Jonathan Rowley - VY License Renewal Application Amendment 22

Docket No. 50-271
Bvy 06-100
TAC No. MC 9670

**Subject: Vermont Yankee Nuclear Power Station
License No. DPR-28 (Docket No. 50-271)
License Renewal Application, Amendment 22
Clarification of Aging Management Program and Environmental Report Items**

Figure 3-2
Chestnut Hill 115-Kv Transmission Line

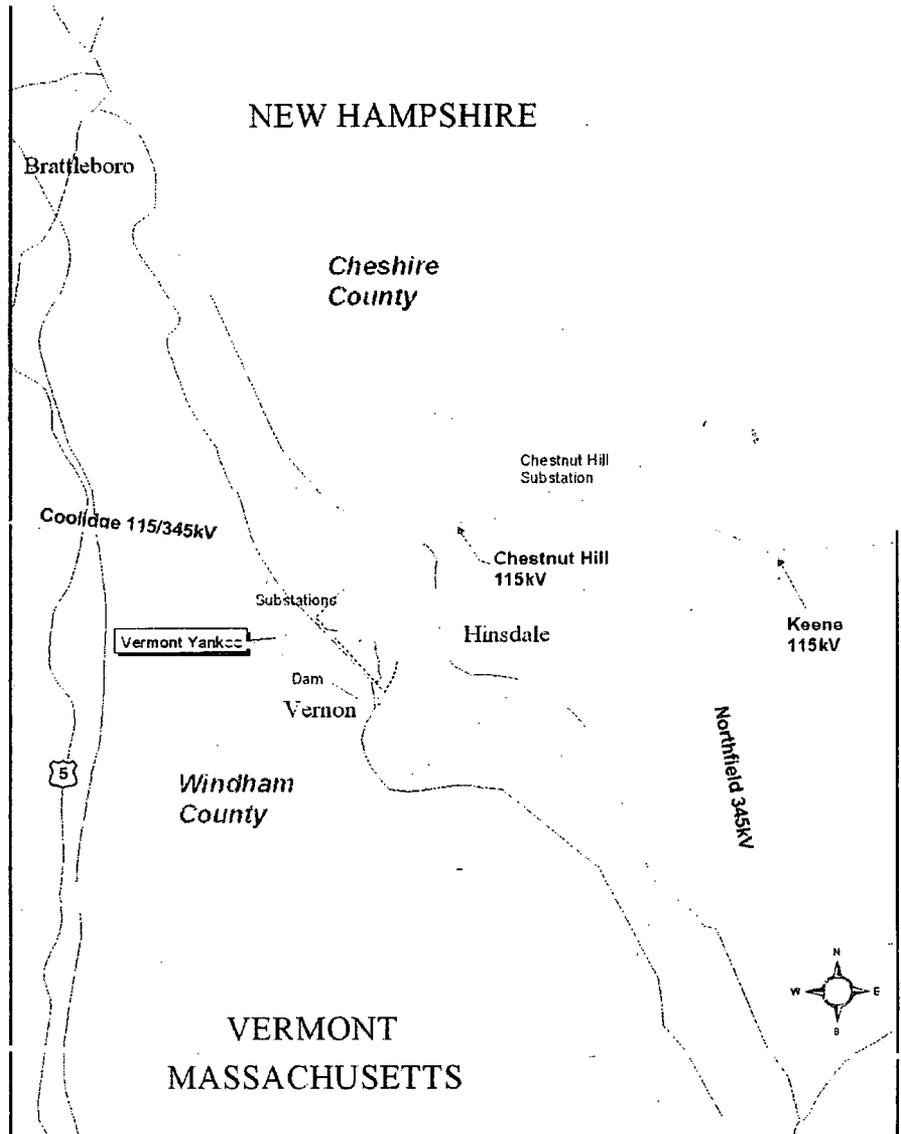
- Attachment 1: RAI 2.3.3.8-1 revised response.
- Attachment 2: Vernon Pool Stratification Information
- Attachment 3: Environmental maps; Figure 3-2 and 3-3
- Attachment 4: RAI 3.5-7 revised response, well sample results and evaluation, Audit Item 350 Clarification
